Product / Process Change Notification (PCN)

PCN Number: PCN_WCAP-FTXX_20240731 Affected Series: WCAP-FTXX Affected Order Codes: 890334xxx; S890334xxx; PCN Date: 2024-04-30 (YYYY-MM-DD) Effective Date: 2024-07-31 (YYYY-MM-DD)		Change Category: ☐ Equipment/Location ☒ General Data ☐ Material ☐ Process ☐ Product Design ☐ Shipping/Packaging ☐ Supplier ☐ Software		
Contact: Product Management Phone: +49 (0) 7942 - 945 5001 Fax: +49 (0) 7942 - 945 5179 E-Mail: pcn.eisos@we-online.com		Datasheet Change: ☒ Yes ☐ No Attachment: ☐ Yes ☒ No		
Description of Change: Because of a database mismatch, Würth Elektronik will update datasheets for the series WCAP-FTXX. This is a datasheet correction only. There will be no change in form, fit, function, quality or reliability of the product.				
Affected Order Codes:				
890334022007	890334022017	890334023006	890334023007	890334023008
890334023010	890334023011	890334023015	890334023017	890334023019
890334023021	890334023023	890334023024	890334023025	890334023028

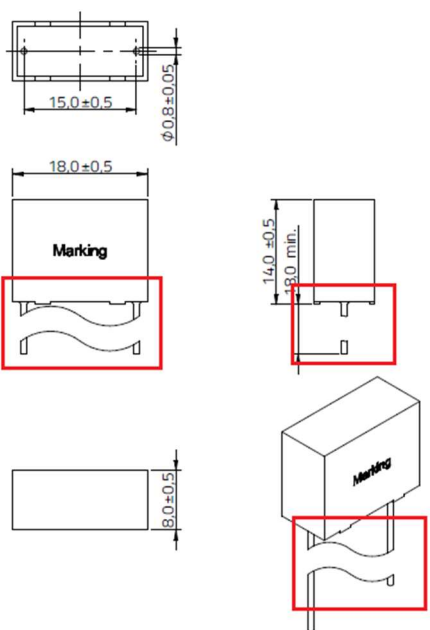
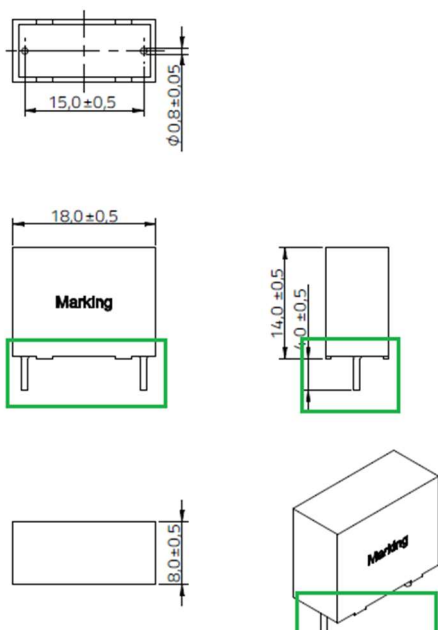
- Würth Elektronik will update the **Pin length** for below order codes and in the meantime this change will show directly on **Component Drawing**.

- Würth Elektronik will update the **Pin length** for 890334025039CS and in the meantime this change will show directly on the **Component Drawing**.

Before Change	After Change
Old Pin length "18,0 min." 	New Pin length "4,0 ±0,5"
